Campaign Update CA#9983

Subject: Solar Panel Reinforcement
Affects certain 2022 Wonder W24RL motorhomes

QAAR 9983 W24RL Zamp Solar Panel Roof Reinforcement

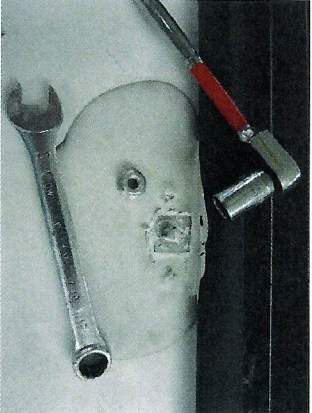
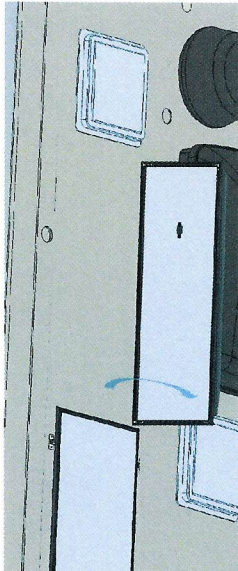
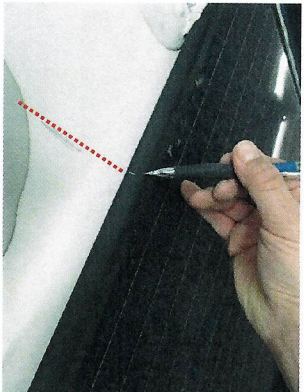
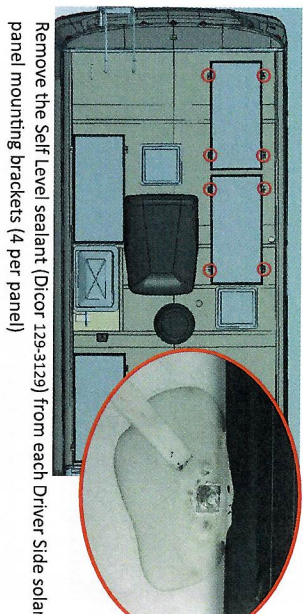
The Zamp solar panels were not being secured to the roof through the galvanized backing as intended.

Repair Kit Eight (8) #10 X 3/4" Robertson (square) panhead screws (141-0204) 8 X           Solar Panel Hardware Kit 127-0261 Four (4) Bolts Four (4) Flange nuts Four (4) T-nuts Four (4) mounting brackets  1. Bolt 2. Flange nut 3. T-nut 4. Mounting bracket 5. Mounting plate 1	Tools • Phillips screw driver • 7/16" socket/wrench • In-lbs torque wrench • Electronic stud finder • Sikaflex 505UV (129-2146) • Dico Self-leveling Sealant (129-3129) • Caulking gun • Cordless driver • Robertson Driver bit • Methanol/Isopropyl Alcohol • 220grit sandpaper 2
 Remove the flange nut from each mounting bracket with a 7/16" socket. 4	 Use an electronic stud finder to locate the aluminum frame crossmembers in the roof. 5
 Flip each panel up to expose the underside. 7	 Use 220grit sand paper to remove the anodized coating of the underside of the solar panel rail that lines up with the stud mark from step 6. This will be where the new bracket will mount and provides continuity to the metal surface of the solar panel. 8

Use a pencil to mark the center of the stud on the roof on either side of the solar panel as well as the corresponding locations on each DS solar panel. 6	 Insert one T-nut into each solar panel frame at each of the marked stud locations. 9
 Remove the Self Level sealant (Dico 129-3129) from each Driver Side solar panel mounting Brackets (4 per panel) 3
